# Access Compliance Report

## Public Rights-of-Way

### (Curb Ramps)

Intersection ID: 5967	Main Street: N_TRYON_ST	Cross Street: MCCULLOUGH_DR	Location:	E
ADA ID: 1ACF975675EE	Ramp Type: BlendTrans1	Initial Pass/Fail: Fail	Overall Compliance: No	Severity Score: 8.75

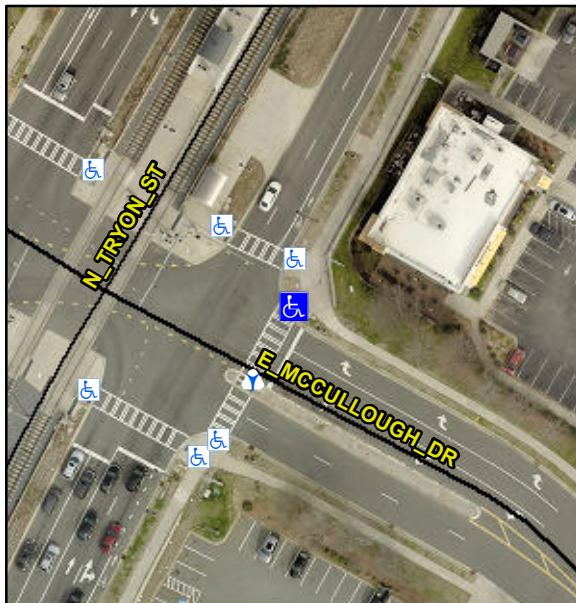
Surveyor Notes:

**DAMAGED DWS**

PROW/ADA:

**Not Found, R304.5.1**

Compliance	Description	Data	Compliance	Description	Data
N/A	Ramp Length (in)	94.0	Yes	BlendTrans Slope (%)	3.6
No	Ramp Width (in)	47.0	Yes	BlendTrans XSlope (%)	2.0
N/A	Flare Type LT	N/A	N/A	Flare Type RT	N/A
N/A	Flare Slope LT (%)	N/A	N/A	Flare Slope RT (%)	N/A
N/A	Flare Traversable LT?	N/A	N/A	Flare Traversable RT?	N/A
N/A	Landing Length (in)	N/A	N/A	DWS Provided?	N/A
N/A	Landing Width (in)	N/A	N/A	DWS Contrast?	N/A
N/A	Landing Slope (%)	N/A	N/A	DWS Length (in)	N/A
N/A	Landing X Slope (%)	N/A	N/A	DWS Full Width?	N/A
N/A	Landing Curb? (Y/N)	N/A	N/A	DWS Offset (in)	N/A
N/A	Shared Landing?	N/A			
N/A	Gutter Ponding?	N/A	N/A	Gutter Slope (%)	N/A
N/A	Gutter Lip Ht (in)	2.0	N/A	Gutter X Slope (%)	N/A
N/A	Painted X Walk1?	Yes	N/A	Painted X Walk2?	N/A
	X Walk 1 Direction	To SW		X Walk 2 Direction	N/A
	X Walk 1 Width (in)	119.0		X Walk 2 Width (in)	N/A
	X Walk 1 Slope (%)	0.9		X Walk 2 Slope (%)	N/A
	X Walk 1 X Slope (%)	3.9		X Walk 2 X Slope (%)	N/A

N/A	Ramp inside XWalk1?	Yes	N/A	Ramp inside XWalk2?	N/A
	Road Slope (%)	3.9		Clear Space?	N/A
	Road X Slope (%)	0.9	N/A	Clear Space to XWalk (in)	N/A
N/A	Any Obstructions?	N/A	N/A	Storm Grate/Utility Hazard?	N/A
	Obstruction Type			Storm Grate/Utility Type	
		N/A			N/A
			Yes	Surface Condition? (G/P)	Good
			No	Curb Slope (%)	7.6

Possible Solutions:

**Remove & Replace Curb Ramp With Two New Directional Ramps or Equivalent.**
